ACCESS REPORT

PROJECT: Northern Rivers Flood Recovery – Richmond River High Campus Redevelopment
PROJECT NO: GDL240133
PREPARED FOR: The Department of Education (DoE)
REVISION: F
DATE: 14.07.2025

DRAWING : BUILDING B - FURNITURE PLAN GF

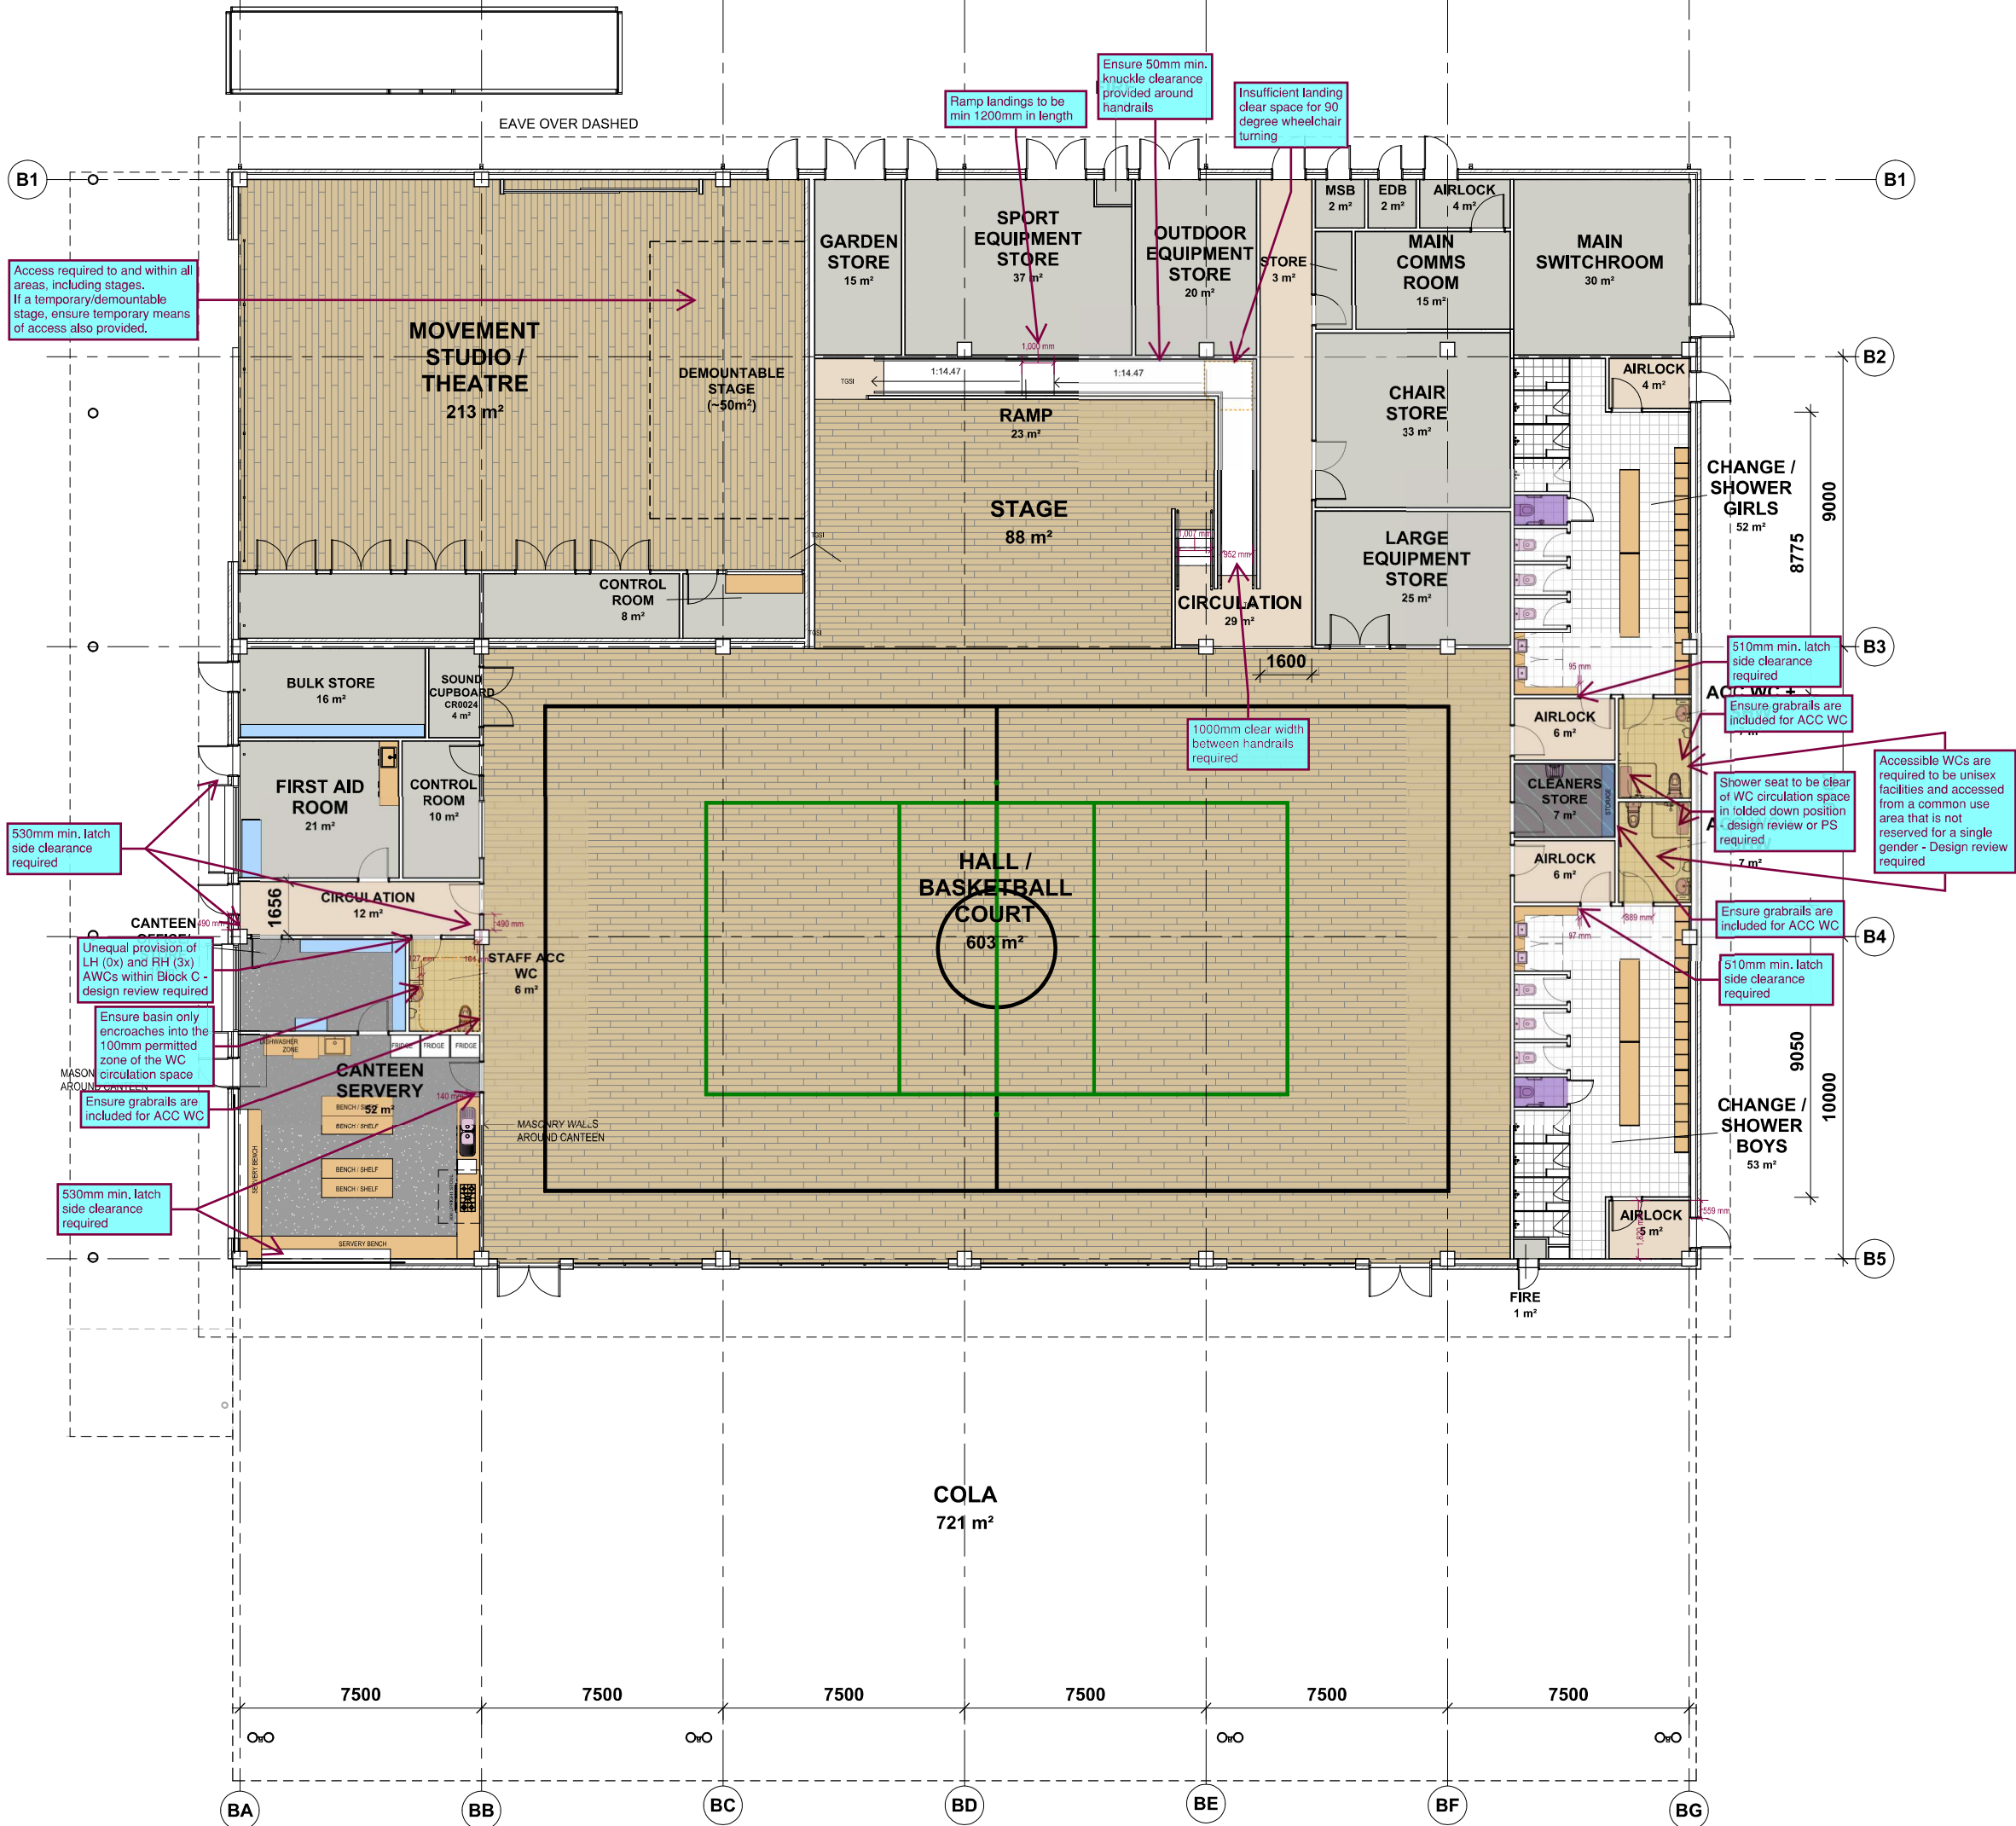
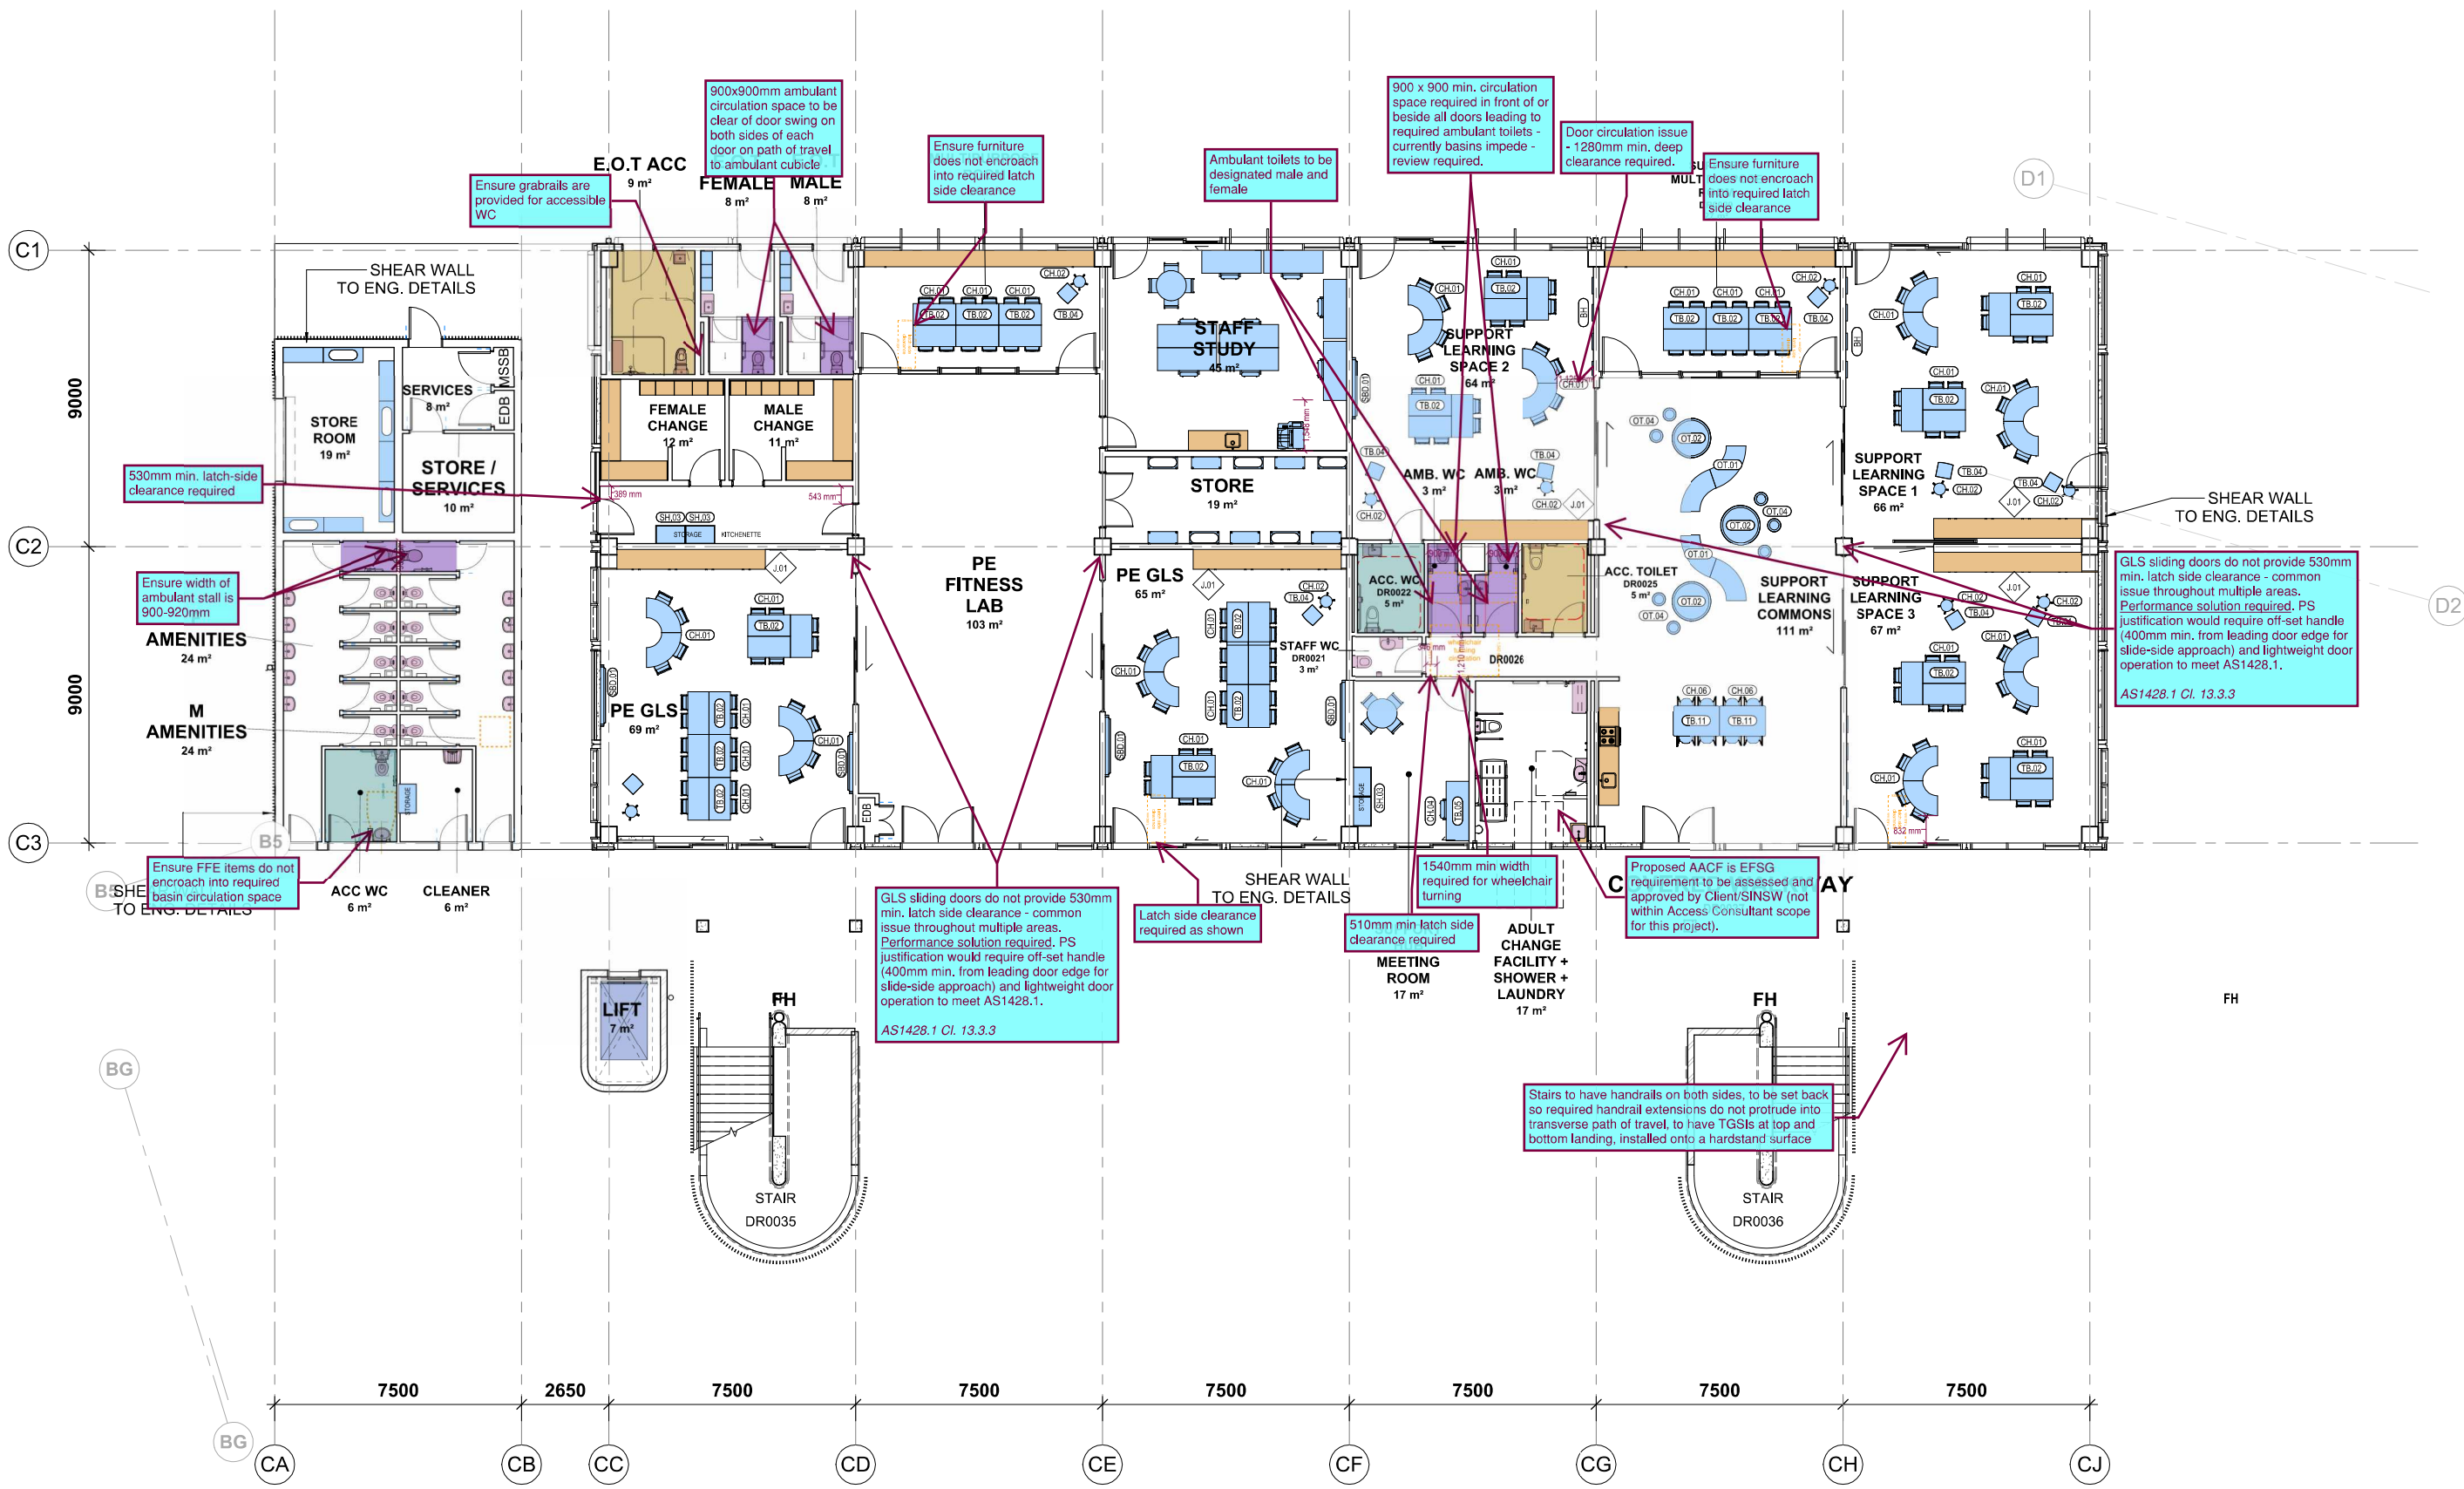
Ensure grabrails are included for ACC WC

Shower seat to be clear of WC circulation space in folded down position - design review or PS required

Ensure grabrails are included for ACC WC
